SUBJECT: NuScale Power, LLC Response to NRC Request for Additional Information No. 214 (eRAI No. 8858) on the NuScale Design Certification Application

Response to Request for Additional Information Docket No. 52-048

eRAI No.: 8858

NRC Question No.: 03.08.02-1

Figure 3.8.2-1: Containment Vessel Components and Building Elevations

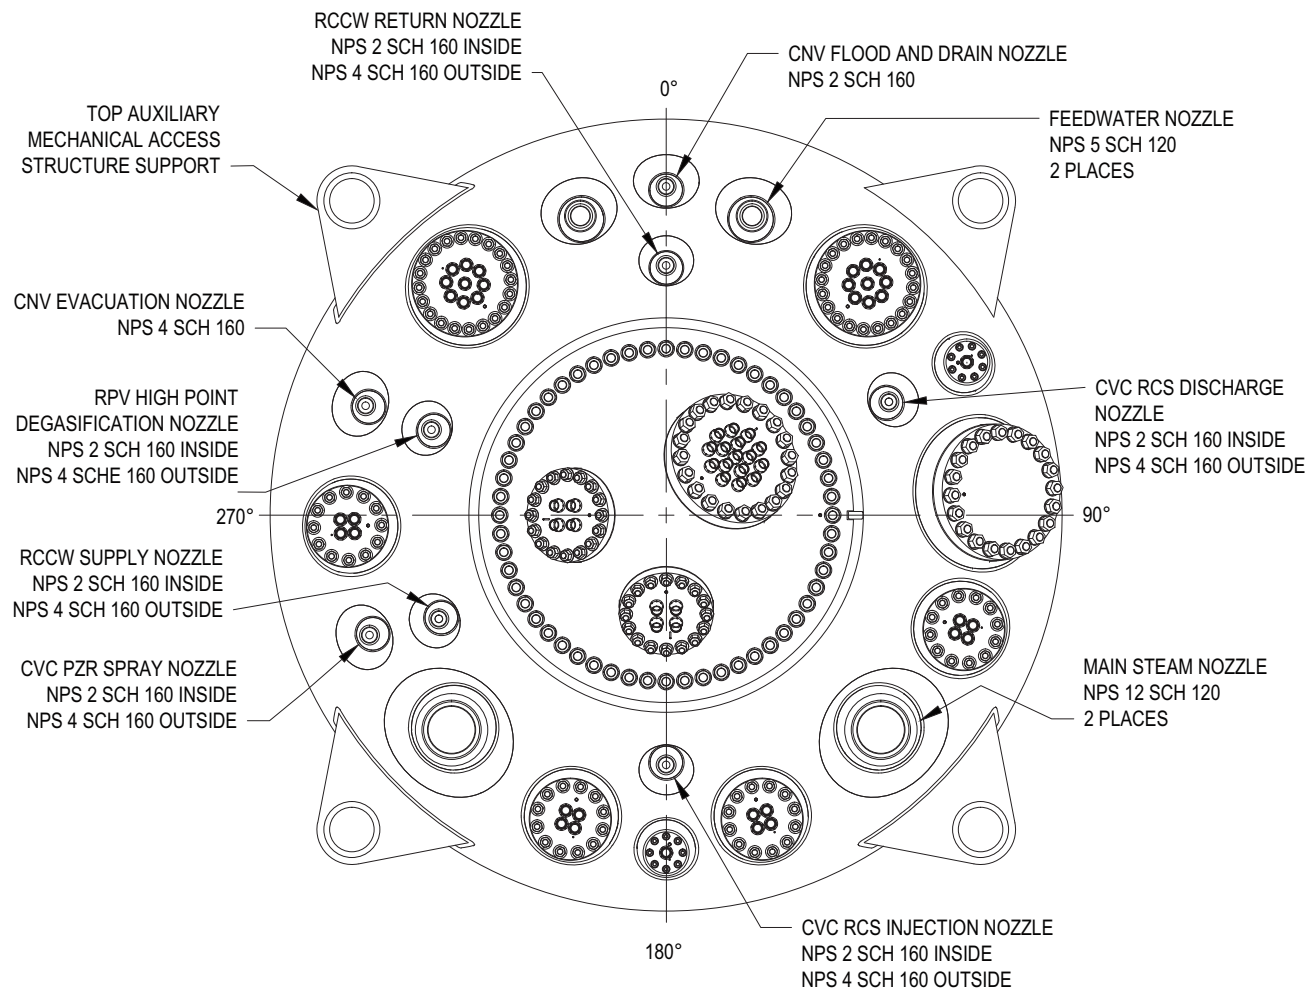
The two figures referenced in DCD Section 3.8.2.1, Figure 3.8.2-1 and Figure 6.2-1 do not provide the geometry of the containment vessel, including sketches showing plan views at various elevations and sections in at least two orthogonal directions. The drawings should indicate ASME Class or Quality Group boundaries, and some drawings are missing measurements. For example, drawings of boundaries between the CNV and the RPV should be provided (RPV support and support ledge) and elevation drawings showing the dimensions from the bottom of the CNV support to the important features of the CNV such as the refueling flange, the centerline of the various access ports, and the RVV trip and trip/reset housing penetrations. Provide the various sketches showing plan views.

The dimensions in the text of FSAR Tier 2, Section 3.8.2.1.2 through Section 3.8.2.1.9 have been added to FSAR Tier 2, Figure 3.8.2-1, Figure 3.8.2-4, Figure 3.8.2-5, Figure 3.8.2-7, Figure 6.2-1, Figure 6.2-2a and Figure 6.2-3a. Views of the containment vessel-reactor pressure vessel (CNV-RPV) boundary at the supports have been added as Figure 3.8.2-8 and Figure 3.8.2-9. Reference to figures showing the plan views, figures providing dimensions, and the new figures identifying the CNV boundary have been added to Section 3.8.2.1.2.

The FSAR Tier 2, Section 3.8.2.1.2 and Figure 3.8.2-1, Figure 3.8.2-4, Figure 3.8.2-5, Figure 3.8.2-7, Figure 6.2-1, Figure 6.2-2a, and Figure 6.2-3a have been revised as described in the response above and as shown in the markup provided with the response to question 03.08.02-12.
